UNITED STATES PATENT AND TRADEMARK OFFICE

APPLICATION NO.	FILING DATE	FIRST NAMED INVENTOR	ATTORNEY DOCKET NO.	CONFIRMATION NO.
10/782,282	02/19/2004	Armand Bettinelli	PF030040	4246
24498	7590	03/23/2005	EXAMINER	
THOMSON LICENSING INC. PATENT OPERATIONS PO BOX 5312 PRINCETON, NJ 08543-5312			MACCHIAROLO, PETER J	
			ART UNIT	PAPER NUMBER
			2879

<b>Office Action Summary</b>	Application No.	Applicant(s)	
	10/782,282	BETTINELLI ET AL.	
	Examiner	Art Unit	
	Peter J. Macchiarolo	2879

## **DETAILED ACTION**

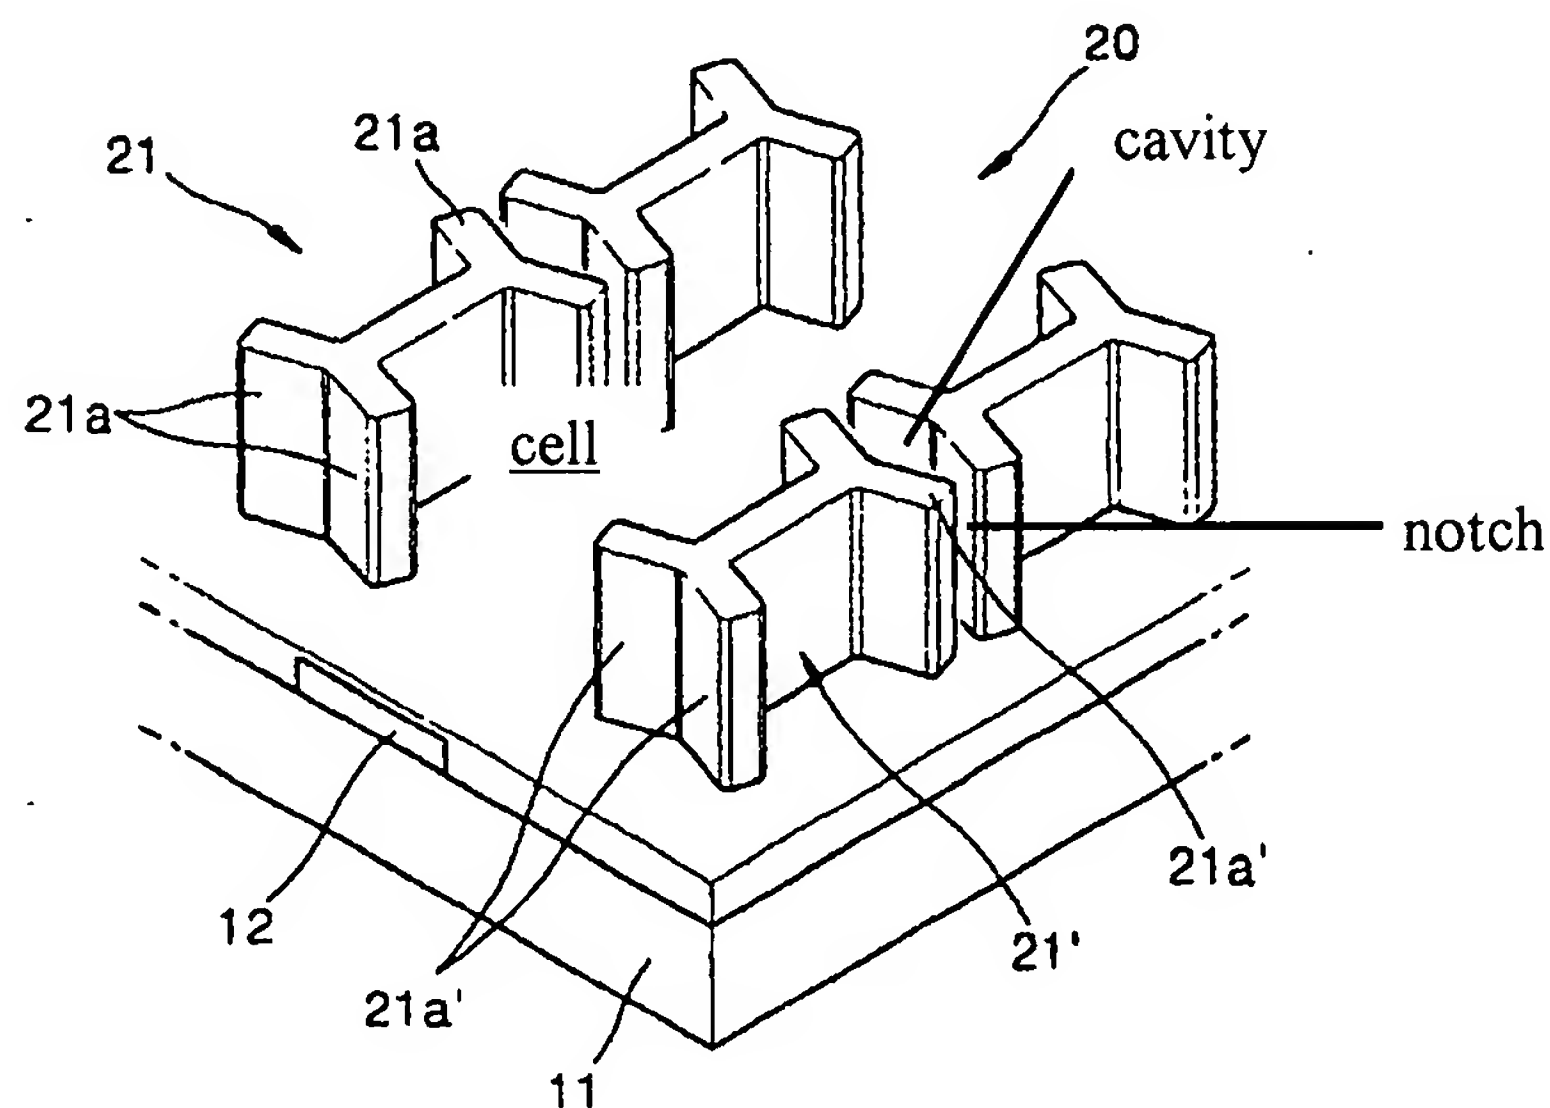
6. Regarding claim 1, Kang shows in figures 2 and 3, a plasma panel comprising two plates (40, 11) leaving a sealed space between them, which space is filled with discharge gas and is divided into discharge cells (reproduced below) that are bounded between these plates by barrier ribs (21) forming an array, the said cells being distributed in rows and columns, characterized in

that the barrier rib portion that separates any two adjacent cells of the same column includes a cavity (reproduced below) that is made in the thickness of the said rib and emerges at the top of the said rib, and also includes a notch (reproduced below) that brings the two said cells into communication with each other through the said cavity.

7. Regarding claim 2, Kang shows in figure 2 that the depth of the said cavities is greater than one third of the height of the barrier ribs.
